UN Regulation No. 39

Speedometer / odometer

Odometer display and units

Explanatory document to the proposed changes to UN R39

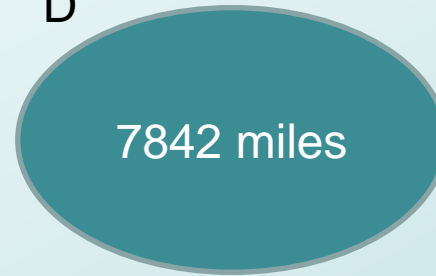
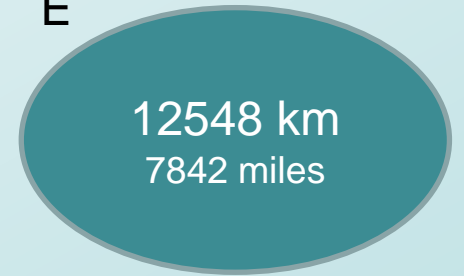
Paragraph 5.5.1

If a setting makes it possible for the driver to choose between a total distance recorded by the vehicle since its entry into service in kilometres and miles, then the distance may be displayed **only** in either kilometres **and/or** miles **at any one time**.

~~The corresponding unit shall permanently be displayed. An odometer value shall not be displayed without its corresponding unit.~~”

Wording in red clarifies that:

- a. distances may be:
 - i. displayed in km (C) or miles (D), or
 - ii. simultaneously in km and miles, and that (E)
- b. a value must always be displayed with its corresponding unit ((A) & (B) are prohibited)
